## HISTORIC AND DESIGN REVIEW COMMISSION

**HDRC CASE NO:** 2021-369  
**ADDRESS:** 1235 E CROCKETT ST  
**LEGAL DESCRIPTION:** NCB 1373 BLK 1 LOT S 89.45 FT OF 27 (AKA S 125 FT OF 27)  
**ZONING:** RM-4, H  
**CITY COUNCIL DIST.:** 2  
**DISTRICT:** Dignowity Hill Historic District  
**APPLICANT:** Samuel Tripp/TRIPP FLIP LLC  
**OWNER:** TRIPP FLIP LLC  
**TYPE OF WORK:** Amendments to a previously approved design regarding porch decking, columns and porch railing  
**APPLICATION RECEIVED:** July 24, 2021  
**60-DAY REVIEW:** Not applicable due to City Council Emergency Orders  
**CASE MANAGER:** Edward Hall

### REQUEST:

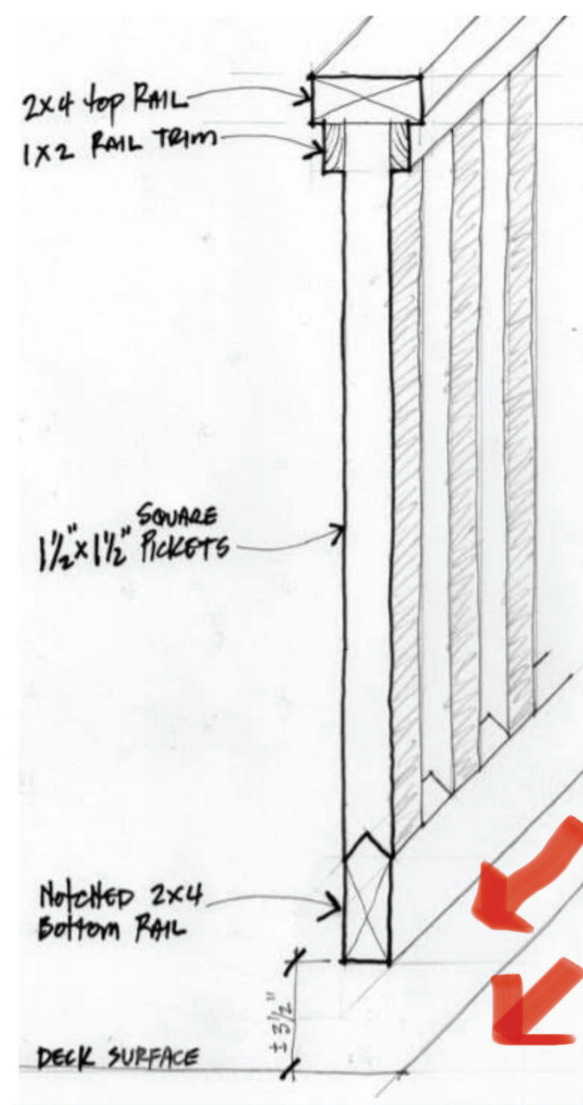
2.) That the proposed porch railing features a 2x4 top rail, 1x2 trim beneath the top rail, 1 ½" x 1 ½" square pickets, and a notched 2x4 bottom rail.

\* The top rail and square pickets are correct.

\* The rail trim piece is about 1.25 inches too long, but it does match the bottom rail and is placed correctly below the top rail.

\* The bottom rail is not notched in, but it is the correct size, and looks identical from the street as the terms of the COA stipulate. We agree that there are minor inconsistencies, but we also feel that the overall product still executes the vision of the COA. It is on this basis that we hope it allows for an amendment to maintain the work as it currently stands.

- e. RAILING – The applicant has proposed to install porch railing that features pickets that extend beneath the bottom rail, as well as a modified top rail and trim profile. Generally, staff finds that the installed railing generally meets the spirit of staff’s standard and does not negatively impact the architectural integrity of the historic structure.

1. Staff does not recommend approval of item #1, porch columns, based on finding d. Staff recommends that the previously approved stipulation for columns be adhered to; the installation of columns that are 6 inches square that feature capital and base trim.
2. Staff recommends approval of item #2, the porch railing as installed, as the railing meets the spirit of staff’s standard and does not negatively impact the architectural integrity of the historic structure.
3. Staff does not recommend approval of item #3, 1x6 porch decking. Staff recommends that the previously approved stipulations be adhered to; 1x3 members installed perpendicular to the front façade.
